Subject: Exelon Nuclear Texas Holdings, LLC
Victoria County Station Early Site Permit Application
Response to Request for Additional Information Letter No. 18
NRC Docket No. 52-042

02.05.02-11

RAI 02.05.02-11:

Figure 1a Houston demonstration site 10 Hz hard rock hazard curves: comparisons of several source models.

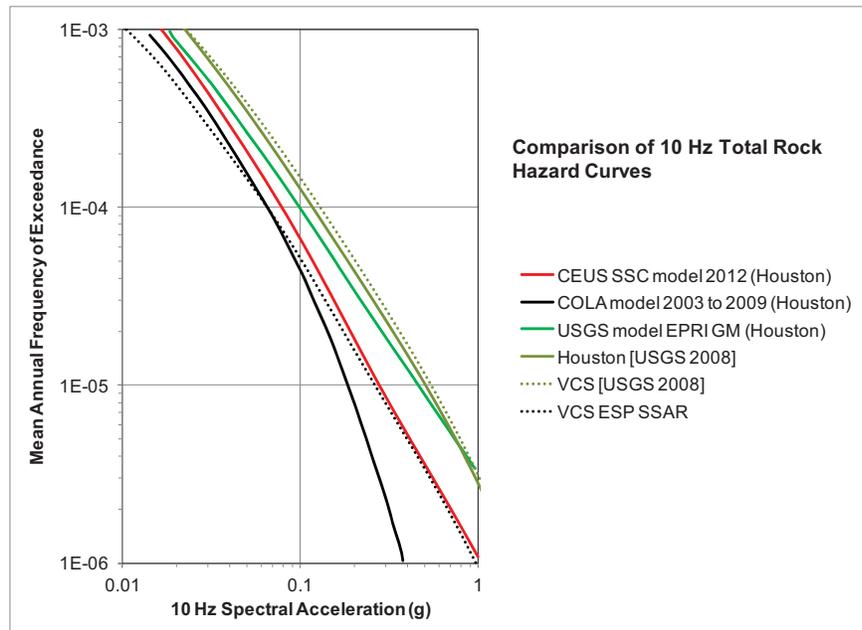
- a) Evaluate the potential impacts of the newly released CEUS-SSC model, with potential local and regional refinements as identified in the CEUS-SSC model, on the seismic hazard curves and the site-specific ground motion response spectra (GMRS). For re-calculation of the PSHA, please follow either the cumulative absolute velocity (CAV) filter or minimum magnitude specifications outlined in Attachment 1 to Seismic Enclosure 1 of the March 12, 2012 letter "Request for information pursuant to title 10 of the *Code of Federal Regulations* 50.54(f) regarding recommendations 2.1, 2.3, and 9.3, of the near-term task force review of insights from the Fukushima Dai-ichi accident." (Agencywide Documents Access and Management System Accession No. ML12053A340).
- b) Modify the site-specific GMRS if you determine changes are necessary given the evaluation performed in part a) above.

The three panels of Figure 1 show comparisons of mean hard rock hazard curves from several source models for 10 Hz, 1 Hz, and PGA response spectral accelerations. The heavy solid lines (from Figures 8.2-3j, 8.2-3k, and 8.2-3l of NRC, 2012a) compare hazard at the Houston, Texas, demonstration site for the current CEUS SSC source model (heavy red line), the USGS model developed for the National Seismic Hazard Mapping Project (Petersen et al., 2008) (heavy bright green line), and a “COLA” model (heavy black line) that has been used for nuclear power plant licensing applications between 2003 and 2009. According to the CEUS SSC report, the “COLA” model is the EPRI-SOG (EPRI, 1988) model updated with more recent characterizations for the New Madrid fault source, the updated Charleston seismic zone, and an update of maximum magnitude values for some seismic sources near the Gulf of Mexico to reflect recent seismicity. Additional details of this “COLA” model are not available in the CEUS SSC report (NRC, 2012a). Calculations of hazard for all three of these models use the EPRI (2004, 2006) ground motion prediction equations (GMPEs) so that the differences in hazard presented among the three models are attributable to differences in the source models themselves.

Also shown in each of these three panels are three additional mean hazard curves that have been included as part of this RAI response. The two olive green lines are hazard curves for the Houston (solid) and the VCS (dotted) sites from the USGS source model and USGS GMPEs. The difference, then, between the solid olive green and solid bright green hazard curves should arise from GMPE differences [EPRI (2004, 2006) vs. Petersen et al. (2008)]. The difference between the two olive green lines [solid and dotted] arises from their different locations within the USGS model.

The third additional line (dotted black line) in each panel is the hard rock VCS ESP SSAR hazard curve for that frequency. Since both the black dotted and heavy black solid hazard curves use the EPRI (2004, 2006) GMPEs and both use updated versions of the EPRI-SOG model these two lines might be expected to match each other closely. This is the case, in fact, only for the 1 Hz hazard curves. The reasons for the differences for the hazard curves at higher frequencies are unknown – and pertinent additional details of the “COLA” model are not available in the CEUS SSC report (NRC, 2012a) -- but could be caused by details of the geographic distribution of local seismic activity rates and/or difference in lower bound magnitudes used in the two analyses.
